# KENWOOD

ASB-1026

## Service Bulletin

**Subject:** TS-950SDX "Click Noise" with NOTCH ON

### Signal Unit (X57-4130-00) Foil Side View

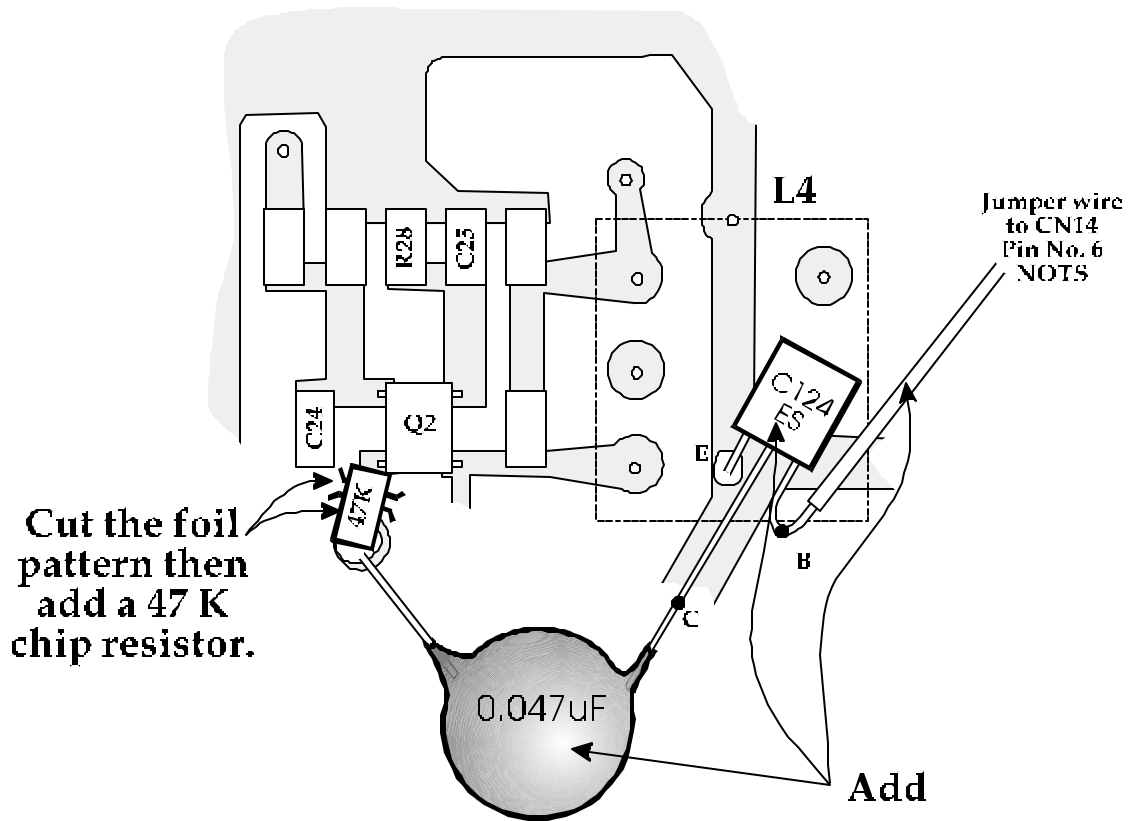
A click noise might be generated when receiving a strong signal (S-9 or above) when the NOTCH is ON and the Notch Control is turned away from the notch point.

Lengthening the AGC release time of the IF Amp just before the NOTCH circuit will correct this symptom. The enclosed modification has been designed to change the time constant only when the NOTCH circuit is activated. Do not install this modification on sets that do not exhibit this symptom as the AGC FAST time constant is affected by this change.

1. Cut the printed circuit foil pattern between the test point (TP) and gate 2 of Q2 as shown.
2. Install the 47 K ohm chip resistor from TP to gate 2 of Q2.
3. Add a 0.047 uF ceramic capacitor as shown in the accompanying illustration.
4. Add the DTC124ES transistor as shown.

*Note: The .047 uF capacitor and the digital transistor must be connected together as shown and installed so that they do not touch the surrounding circuit board patterns.*

5. Install a jumper wire from the base of the digital transistor to pin number 6 of CN14.
